VIEUX CARRE COMMISSION

AGENDA

WEDNESDAY, AUGUST 18TH, 2021

**Vieux Carré Commission Meeting of** **08/18/2021**

**EXHIBIT A**

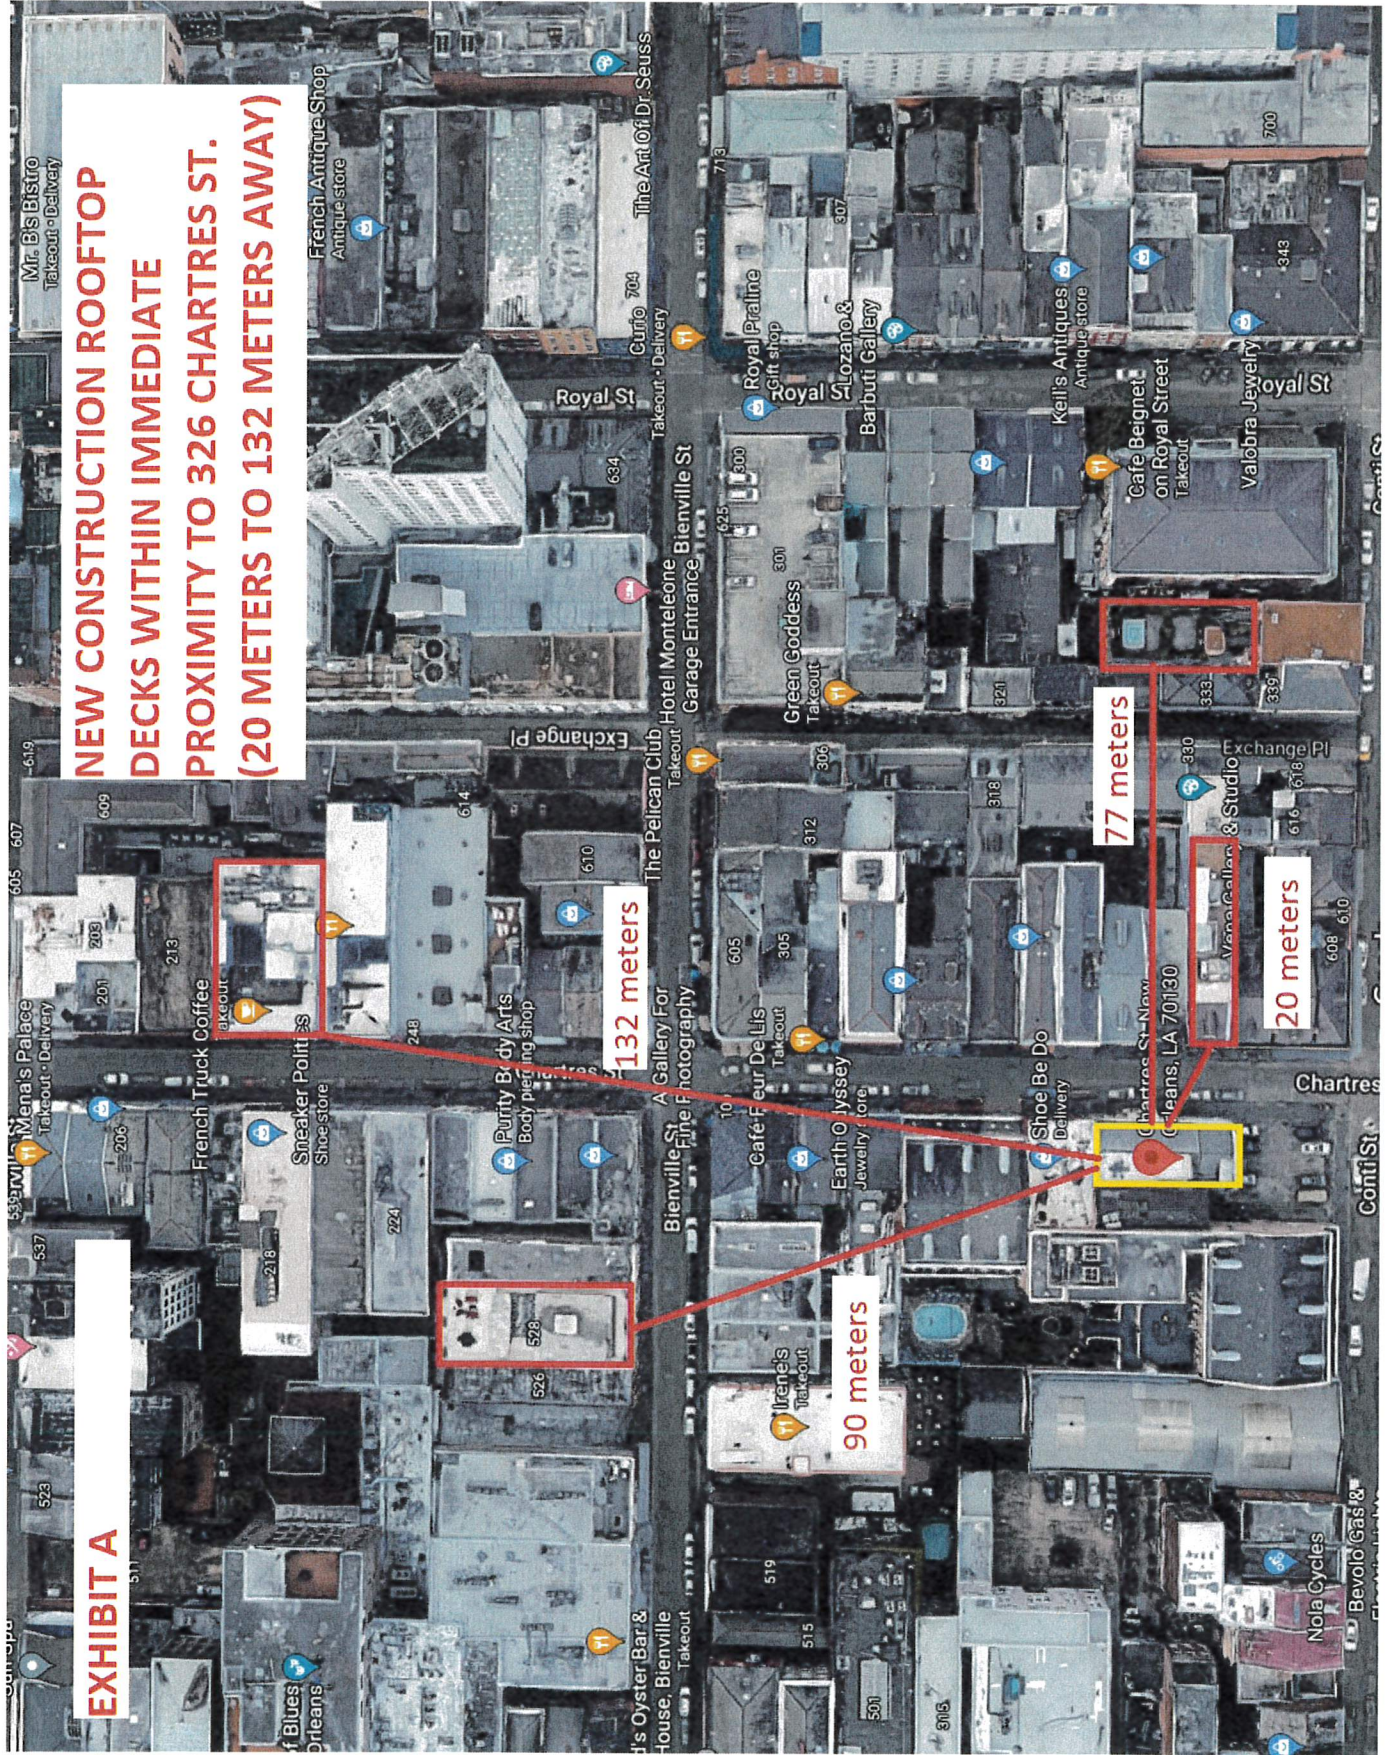
1. ***The rooftop deck is consistent with the surrounding neighborhood properties.*** Currently, within 130 meters from the property, 4 rooftop decks were recently constructed. (See Exhibit A, *Surrounding Rooftop Decks*). One such deck on the 200 block of Chartres St. was constructed on a multifamily property; the deck contained foliage, furniture, and heavy usage by multiple tenants. The rooftop deck that was constructed directly across Chartres St. from the Property, is less than 20 meters away. (See Exhibit B, *Picture of Rooftop Deck Directly Across Chartres St*). It also houses a tall furniture-canopy and is visible from the corner of Chartres and Conti Streets.

appears to be the only deck built on a hipped or gabled roof. All of the examples provided by the applicant were installed on flat roofs, consistent with the Design Guidelines.
